PROJECT	<b>Smithsonian Institution- Revitalization of the Historic Core (RoHC)</b>	MEETING DATE	4/26/2023
ORGANIZER	<b>Smithsonian Institution, Carly Bond (moderator)</b>	TIME	2:00-4:00pm
LOCATION	Virtual/Zoom		
PANELISTS	Carly Bond- Smithsonian Institution Christopher Lethbridge- Smithsonian Institution Brenda Sanchez- Smithsonian Institution Matthew Chalifoux, EYP-Loring Anthony Bochicchio, EYP-Loring Faye Harwell, Rhodeside and Harwell		
SUBJECT	<b>Consulting Parties Meeting #12</b>

## MEETING MINUTES

**Purpose – This was Consulting Parties Meeting 12 for the Revitalization of the Historic Core (RoHC) project of the Smithsonian Institution. The meeting was held in compliance with Section 106 of the National Historic Preservation Act.**

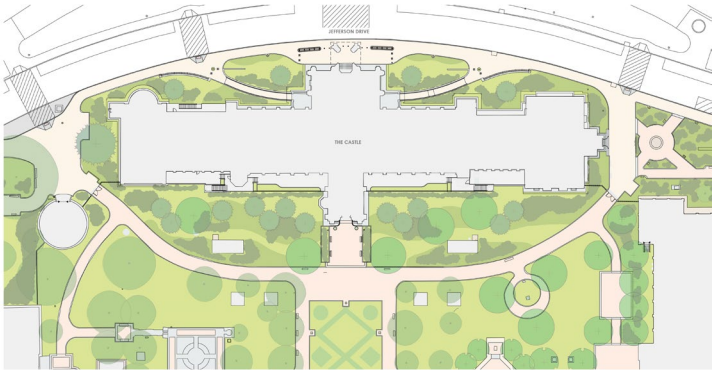
16. **Q:** I encourage documentation of existing landscape elements, i.e. hand tooled gutter, boot scrapers.

**R:** The boot scrapers will be conserved and returned. We will perform further research to determine the age of the tooled gutter. Documentation of the existing features will be performed prior to construction.
